Rezoning Transportation Analysis

Petition Number: 2022-134

Date	Description
01-26-23	First Review (PDM)
02-22-23	Second Review (JP)
03-17-23	Third Review (JP)
03-29-23	Fourth Review (PDM)

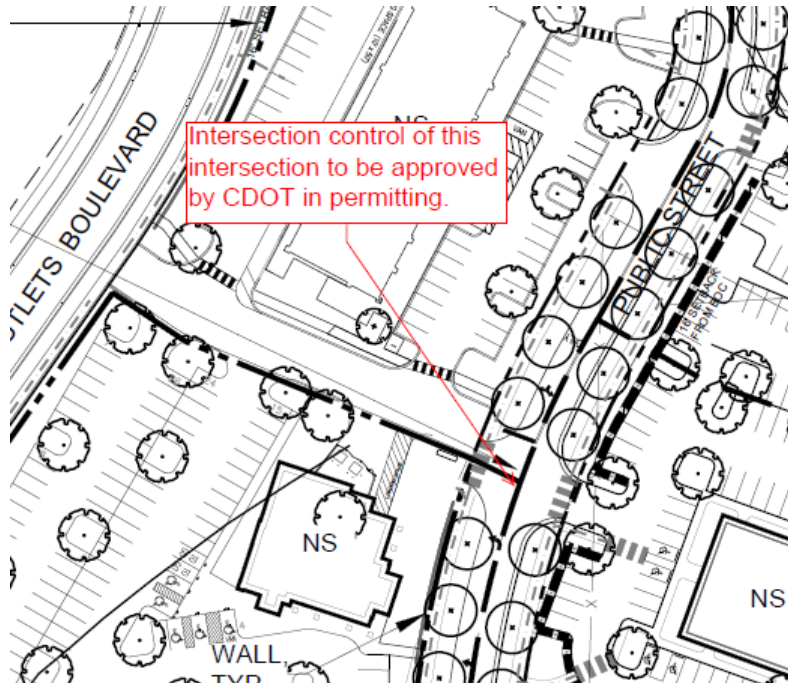
~~3. Add callout and conditional note for the proposed intersection control to be approved by CDOT during permitting for the below intersection.~~

~~Clarifying Comment from 2-22-23:~~ Add conditional note and callout
